5.2 Lam's observations and theory of collapse

5.3 Probable cause of collapse and sequence of events:

PSJA ISD T-STEM EARLY COLLEGE HIGH SCHOOL
(Old Memorial Middle School) - PHASE I
RENOVATIONS AND ADDITIONS
Pharr - San Juan - Alamo Independent School District

EXHIBIT 8

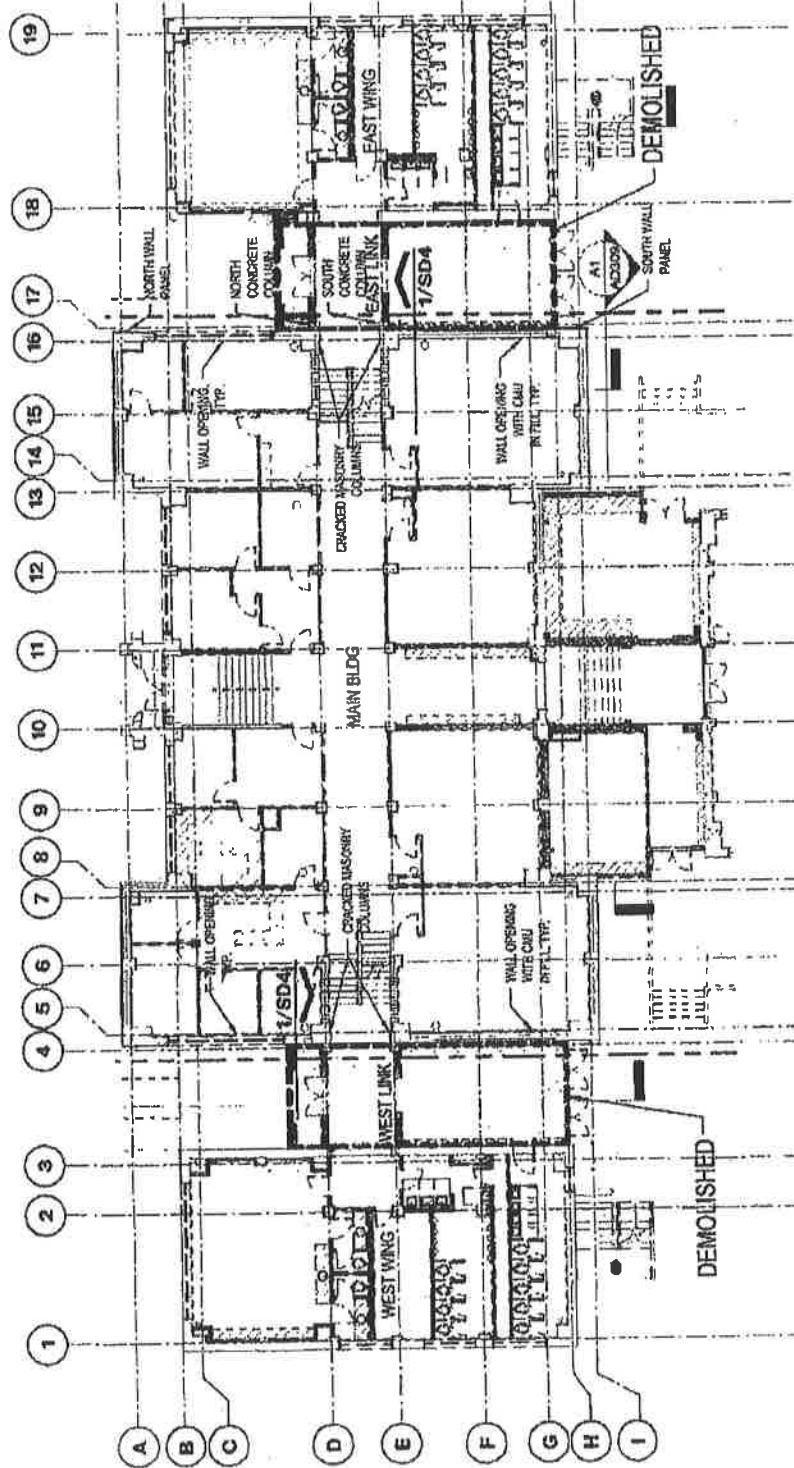
On October 18, 2010 Frank Lam & Associates, Inc. reported on their investigation of the Partial Collapse of the Main Building and included in their report diagramed information pertaining to the damage areas. Refer to Exhibits 8, 9, 10 and 11.

- **"East Link** - The East Link structure was completely demolished with the exception of some rebar spanning between the buildings. During the demolition of the link, an approximately 12 ft by 60 ft long section of the west side of the Main Building was also damaged and collapsed. The collapsed members include the concrete beams and slab at the second floor and roof, load bearing clay tile and brick veneer walls, exterior masonry columns, and concrete masonry unit infill at the wall opening. Part of the second floor and roof slab is still hanging by the rebar and the two wing walls at the north and south of the building are still remaining but have suffered severe damages and separation. The floor and roof beams had rotated and pulled out from the masonry walls, leaving a pocket in the walls. It appears that the collapse stops at the first interior beam along Grid 15." See Exhibits 8, 9, 10 and 11.

EXHIBIT 11

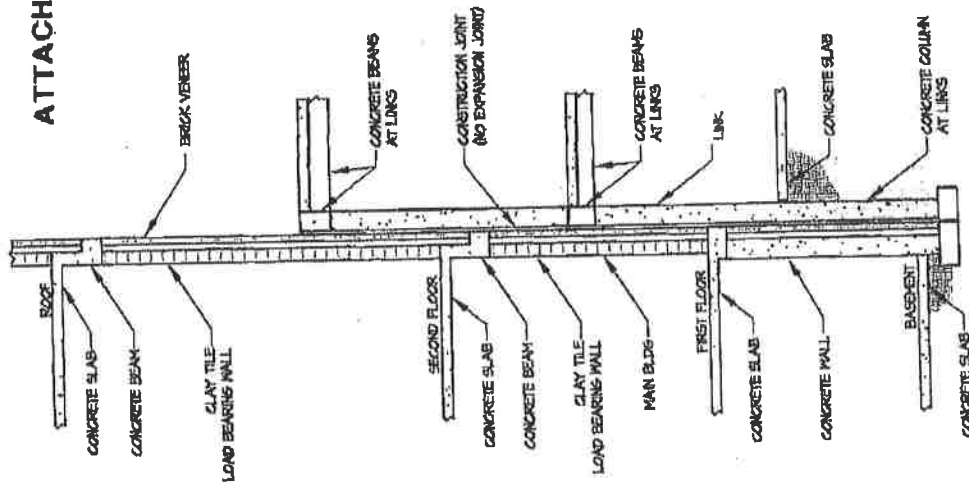
7. Lam: "The lack of expansion joint between this concrete column and masonry column supporting the Main Building allowed the two columns to bond together." I agree, although I am not certain it applies to the ultimate outcome. This condition would have been exposed had Lam conducted proper testing prior to the time that design documents had been prepared.

8. Lam: (At the links), "the newer concrete columns were cast against the existing masonry walls and columns without expansion joints and the columns were plastered together and creating a bond between them. This condition does not allow the columns to move independently and allows force transfer between them; and as a result, Impact from the chipping hammer hitting the concrete column in the Link could have created distress in the masonry column in the Main Building." I agree. On Lam's drawing sheet S102, it can be seen that Lam's preliminary report had failed to disclose the presence of or lack of an expansion joint at grid line 15 (see Exhibits 12, 13, and 14). On Exhibit 12, Lam notes "Contractor to field verify existing condition and contact Structural Engineer" but the note is not clear and does not indicate what the Contractor should be looking for. The plans are incomplete. In professional engineering practice, the engineer would be aware of the hazards of demolishing a narrow "Link" structure between two buildings that are to remain. If the link slab is connected to either the Main Building or the East (or West) Building, forcibly removing slabs with a chipping hammer (instead of sawcutting the Link slabs away) would be a very high risk proposition. In this case, the contractor's actions collapsed the east portion of the building and resulted in damage throughout the building.

EXHIBIT 18

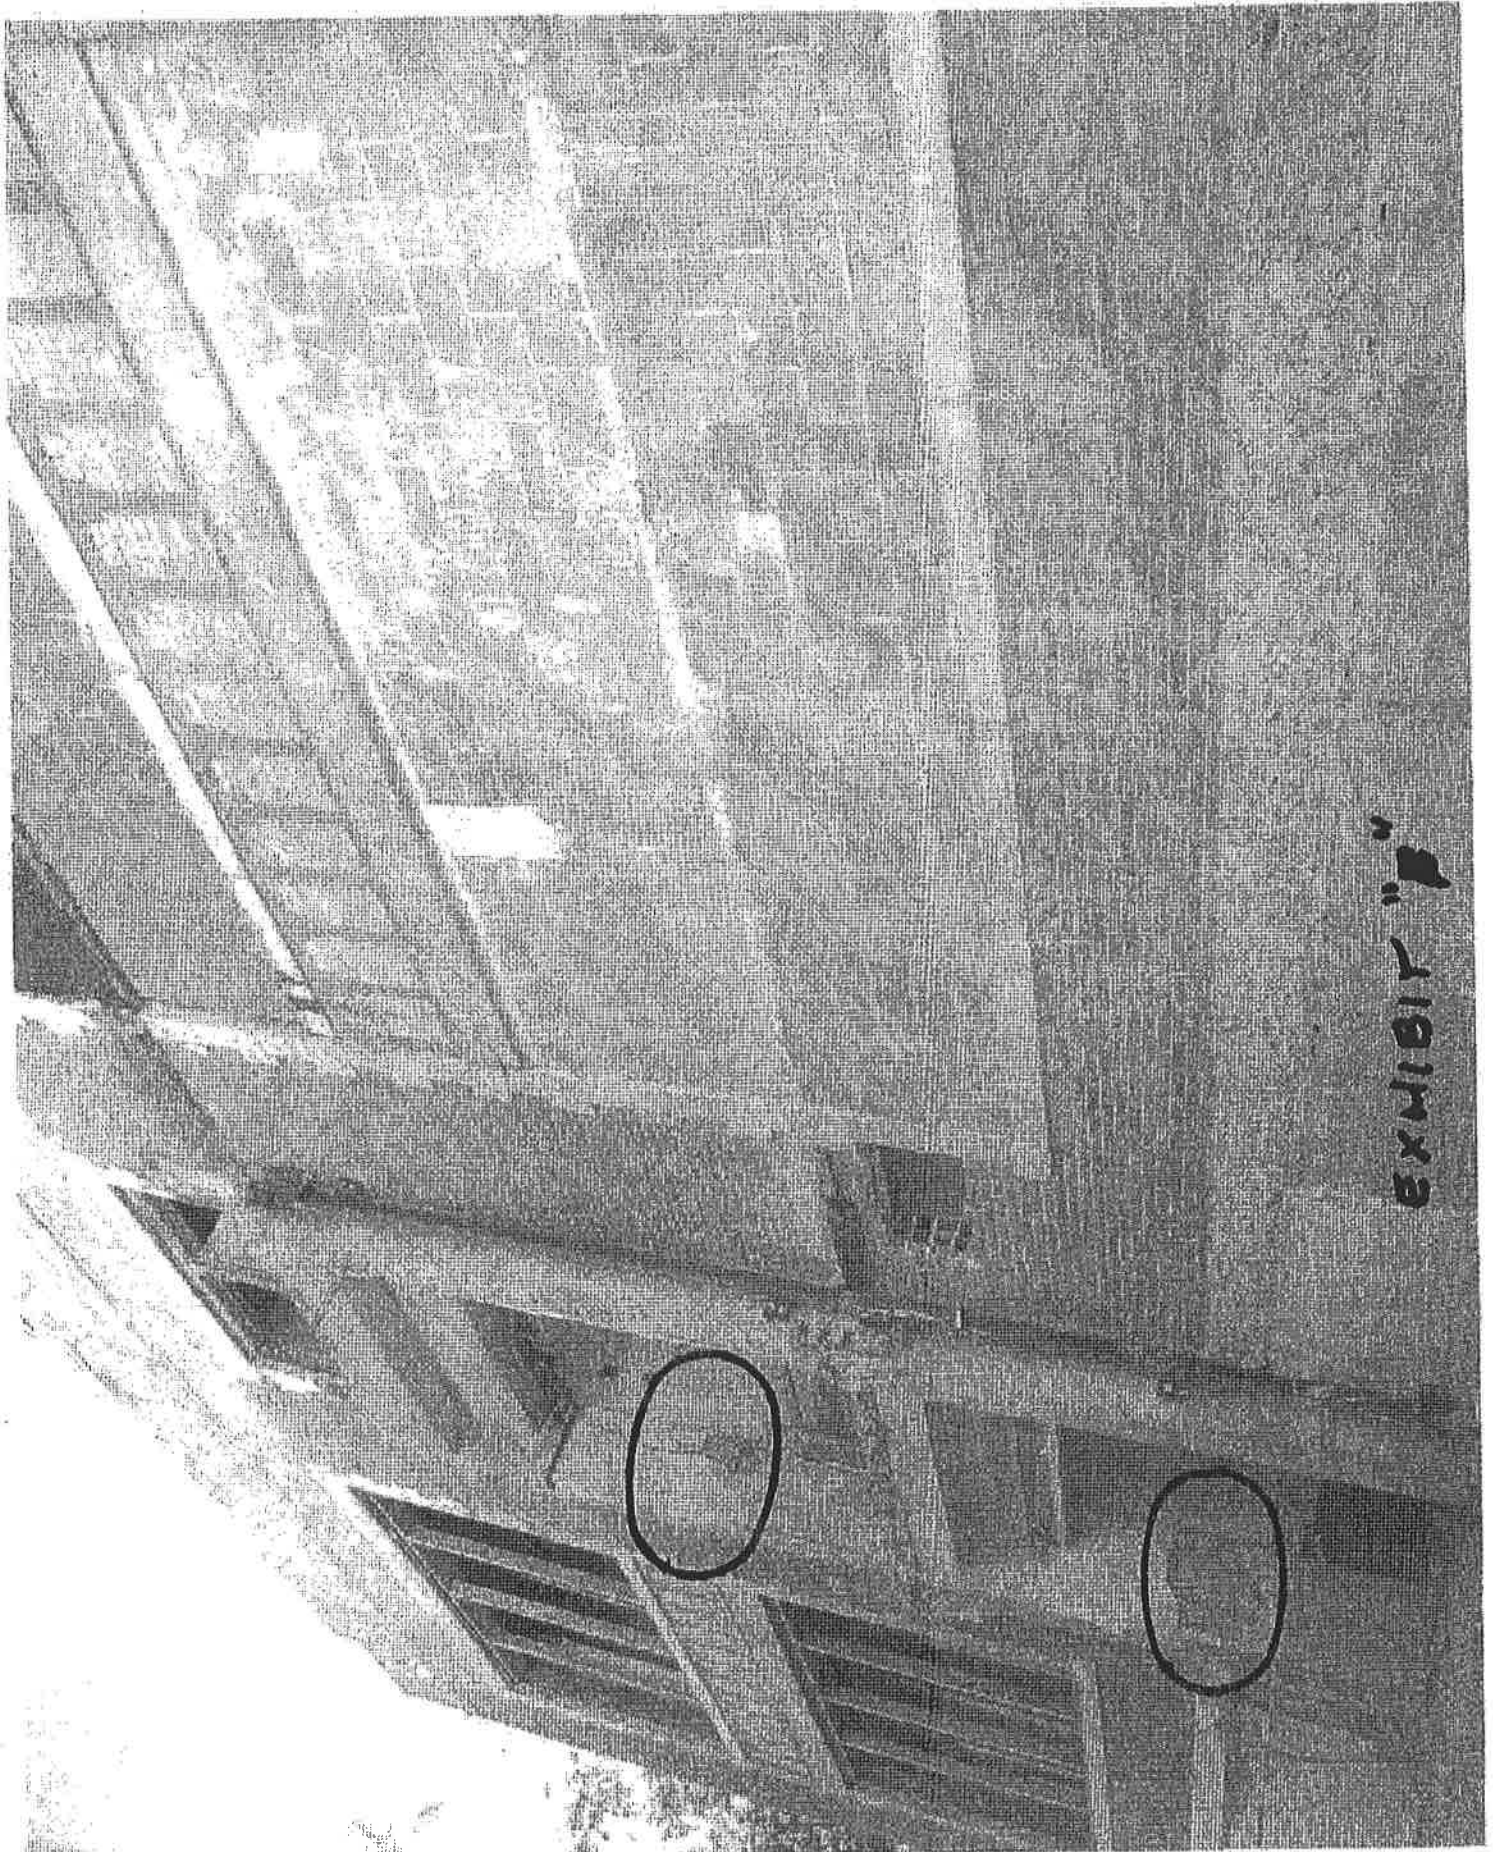
Mr. Morris addressed the west end of the building stating (page 5): "Inspection of the west end of the main building indicated the concrete columns at the sides of the west exit ended near the level of the first floor, with masonry columns extending above that level. We observed cracking in the masonry columns on both sides of the exit above the first-floor level. Concrete columns had been installed at the exterior of the main building for the walkway... (and) there was evidence of movement of the brick veneer on the first floor at the northern portion of the west wall of the main building." See Exhibit 18.

EXHIBIT 19

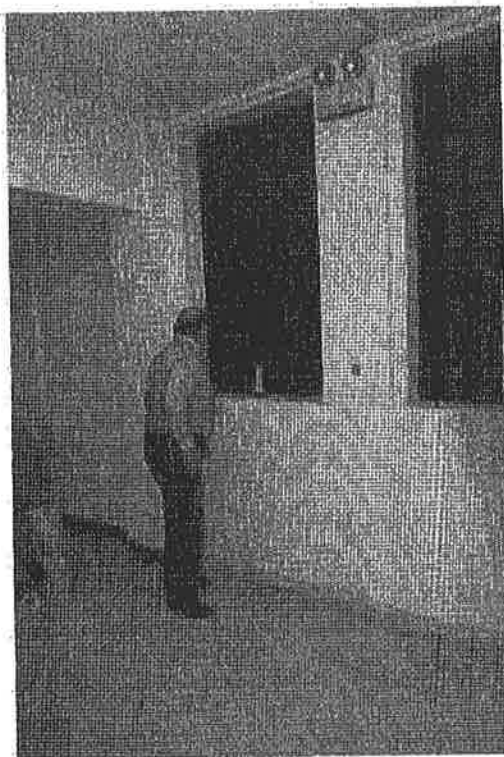
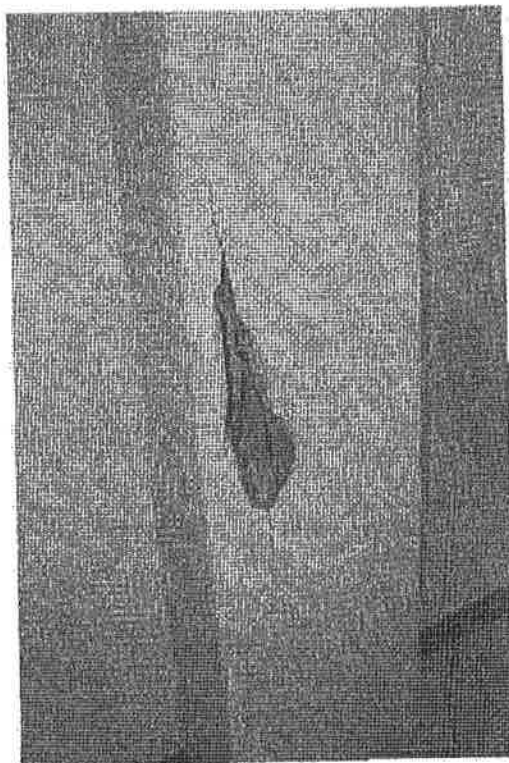
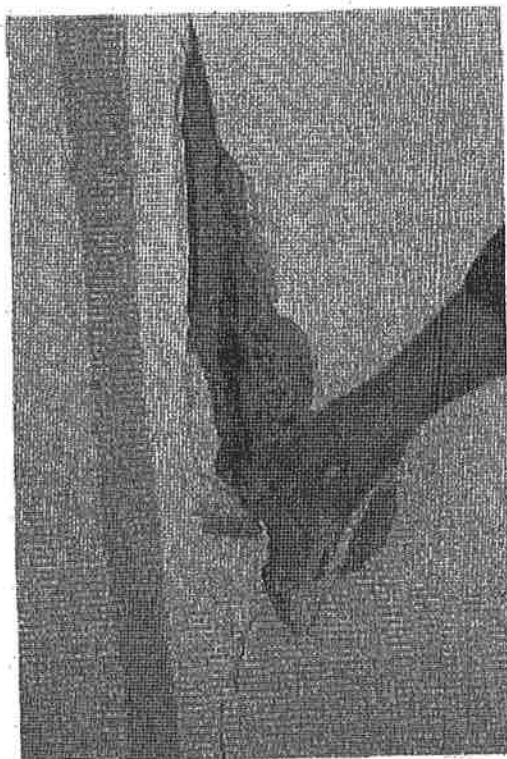
The basement of the Main Building had evidently previously flooded at one time (see Exhibit 19) and moisture intrusion inside the basement has continued to be a problem.
